March 13, 2006  
LIC-06-0021

**SUBJECT: Response to Request for Additional Information Related to Extension Date for Corrective Actions Regarding Generic Letter 2004-02, "Potential Impact of Debris Blockage on Emergency Recirculation During Design Basis Accidents at Pressurized-Water Reactors"**

**Response to Request for Additional Information Related to Extension Date for Corrective Actions Regarding Generic Letter 2004-02, "Potential Impact of Debris Blockage on Emergency Recirculation During Design Basis Accidents at Pressurized-Water Reactors"**

Figure 1

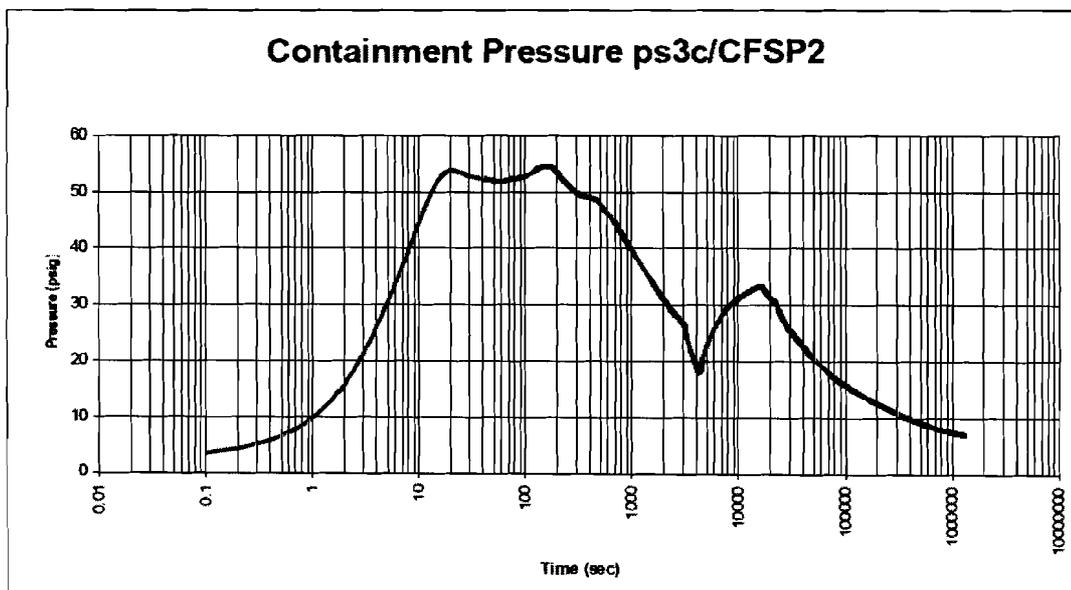
What are the physical stresses on the containment building as a result of the higher water levels using this approach?

The analysis discussed in Section 5.1.B.4.e of EA-FC-04-010, Revision 1, conservatively assumed constant post Recirculation Actuation Signal (RAS) pressure of 40 psig and showed acceptable physical stress on containment. Recently, OPPD has completed a re-analysis of the long-term containment pressure analysis in preparation for the replacement of the steam generators and pressurizer in the fall of 2006. This analysis reflects the larger steam generator and pressurizer water volumes of the replacement components. The following figure shows the results of this analysis:
